TOWN OF JACKSON ZONING ORDINANCE

SEWAGE DISPOSAL SYSTEM PLAN AND DETAILS
LOCATED IN JACKSON, NH

PREPARED FOR:		MARK J. & SUSAN J. ROSS-PARENT	
MAP R12 / LOT 146 GREEN HILL ROAD			
PREPARED BY: BRIGGS LAND SURVEYING		P.O. BOX 1587	
Tel. (603) 447-6647		CONWAY, NH 03818	
SCALE: AS NOTED	NHDES CONSTRUCTION APPROVAL #	FILE NO. - 181106	
DATE: 12 / 20 / 2021		DWG. NO. - SS1

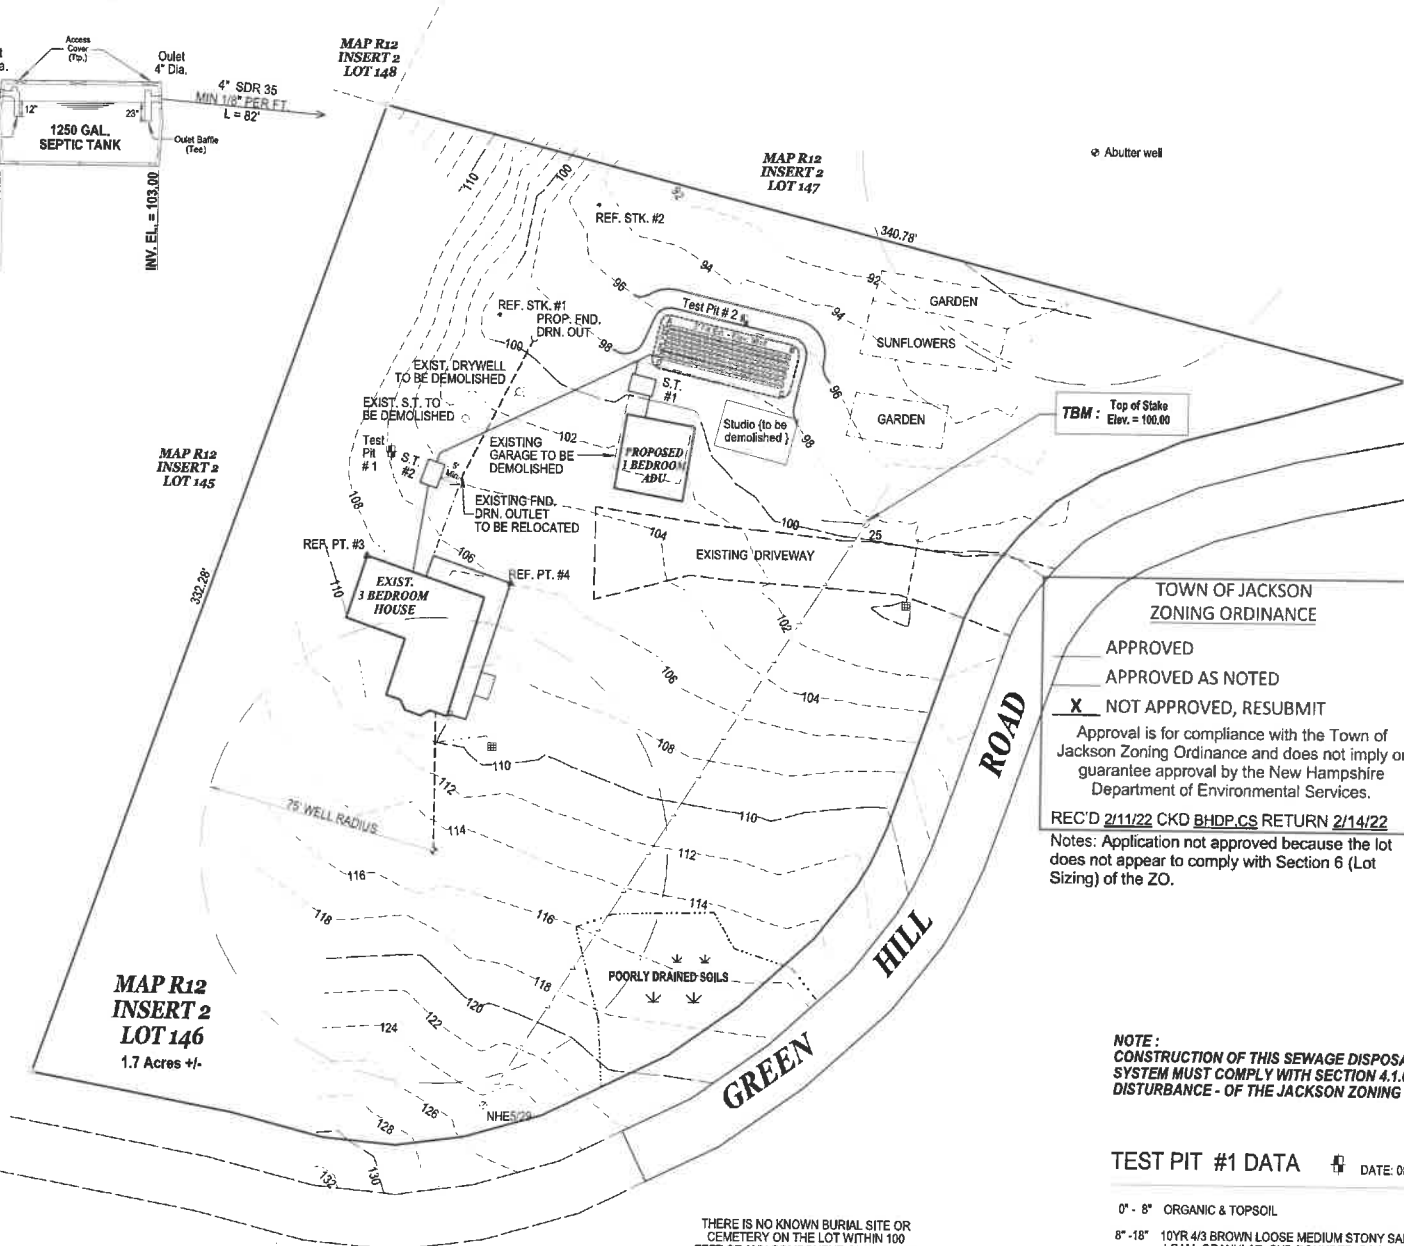
3 BEDROOM REQUIREMENT = 0.63 x 46,000 SQ. FT. = 28,980 SQ. FT.
1 BEDROOM ADU = 0.30 x 46,000 SQ. FT. = 13,800 SQ. FT.
0.40 x 60,500 = 24,200
TOTAL REQ'D. = 61,980 SQ. FT. (52,340 SQ. FT. PROVIDED)
86,515 Town Review Notes

Notes: Application not approved because the lot does not appear to comply with Section 6 (Lot Sizing) of the ZO.
